February 18, 2022

RE: Burger King (1997, 2003, 2007 Ridge Road) – Planning Board submittal

Please find below the Town Engineer comments (*italics*) and our corresponding responses (**bold**).

<b>Grading &amp; Drainage Plan</b>	
Drawing Name:	
Date: 04/19/21	Project No. 21-0239
Type:	C3
Drawn By: SAS	Drawing No.
Scale: 1"=20'

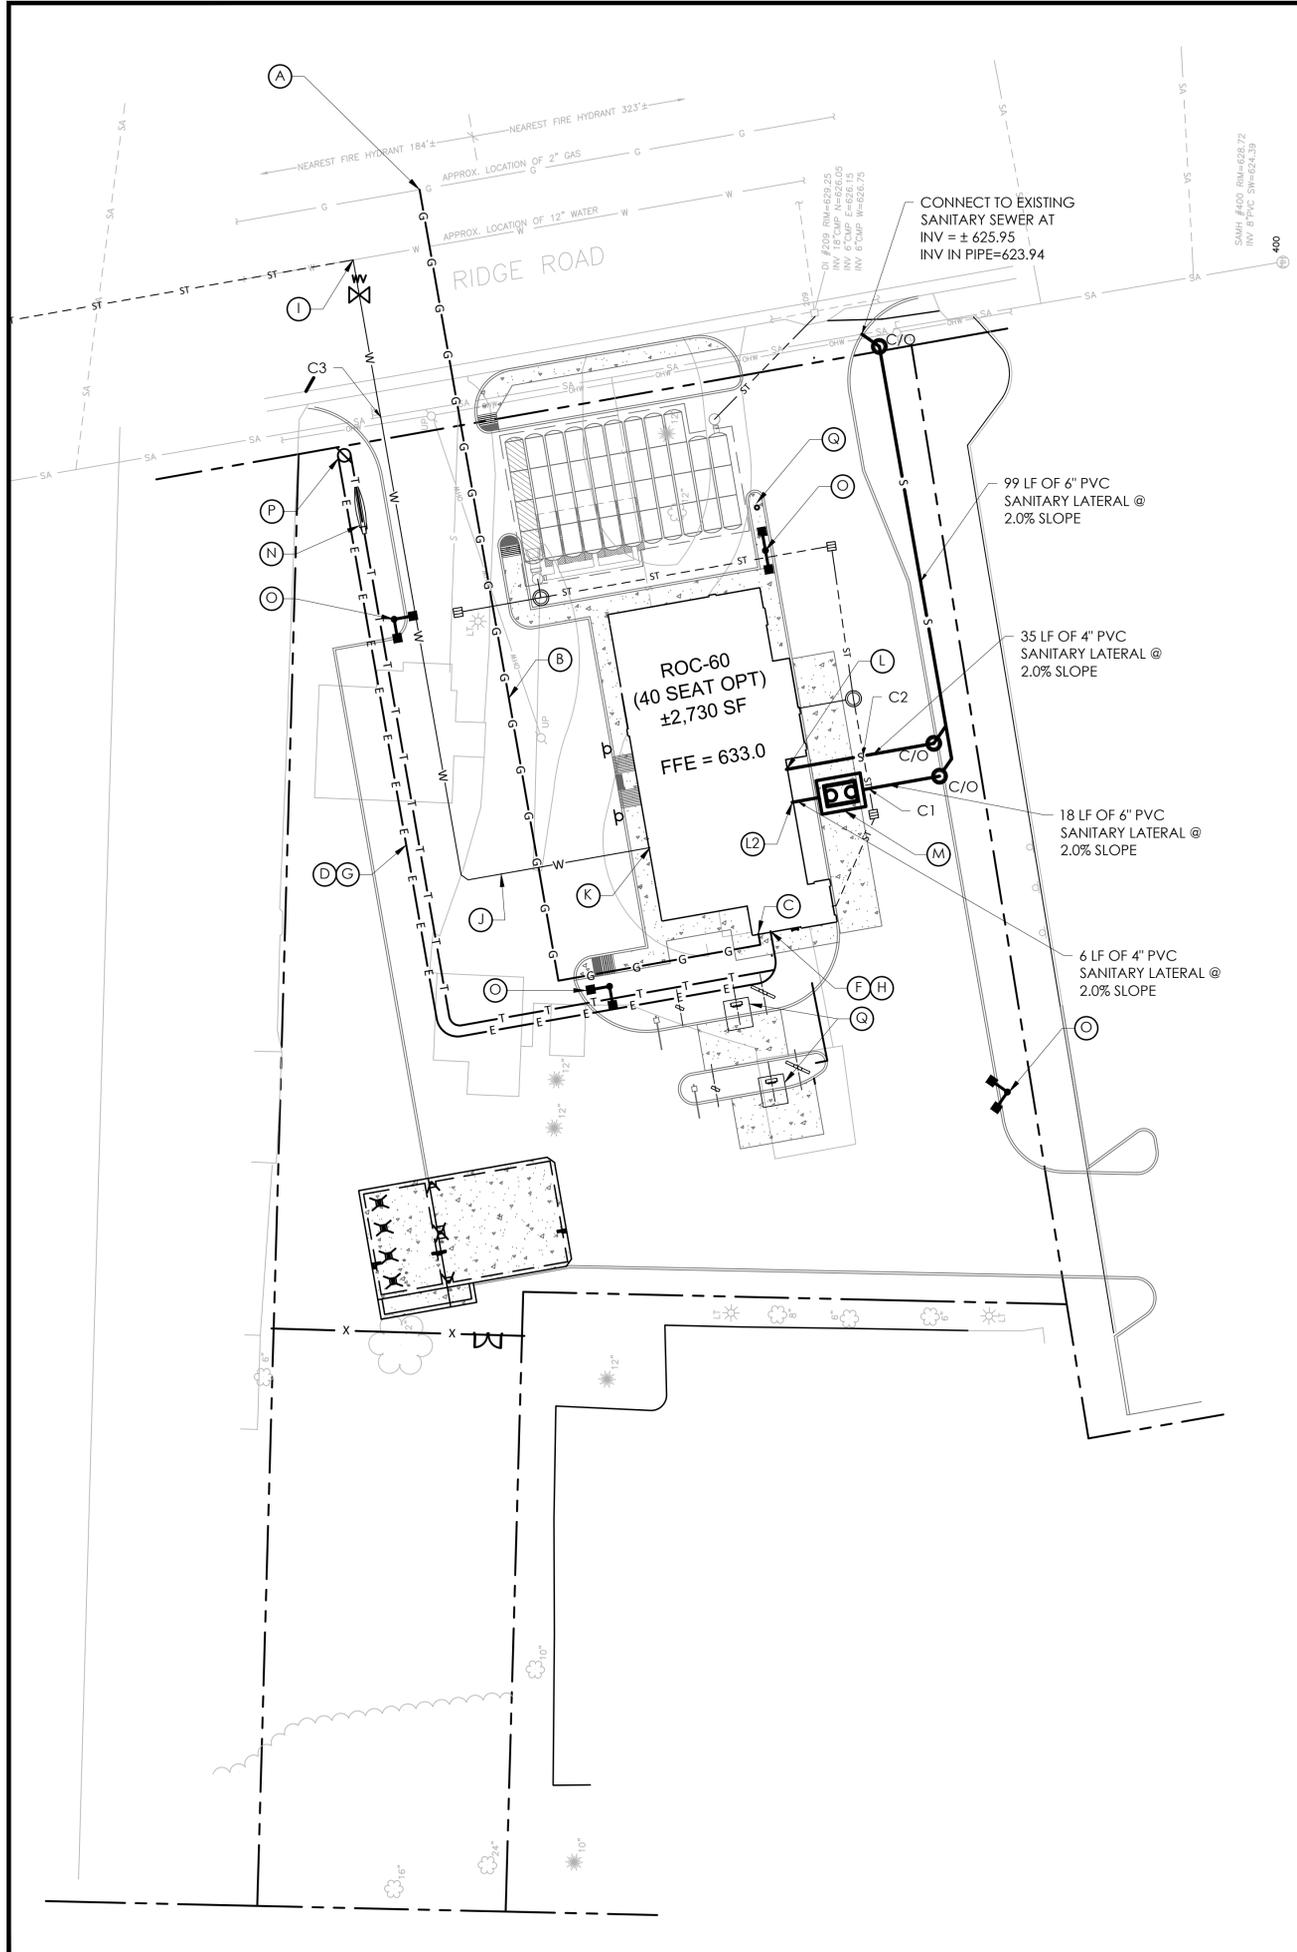
**Acknowledged. Per discussions with the County on 2/18/22, they had not finalized their review or corresponding letter.**
5. *The proposed drainage design could not be properly assessed as several pipe inverts, lengths, sizes and slope were not provided. Pipe sizing calculations must also be provided.*

***Pipe inverts, sizes, and slopes are provided on the revised grading and drainage plan. Pipe sizing is included in the Engineer's Report.***
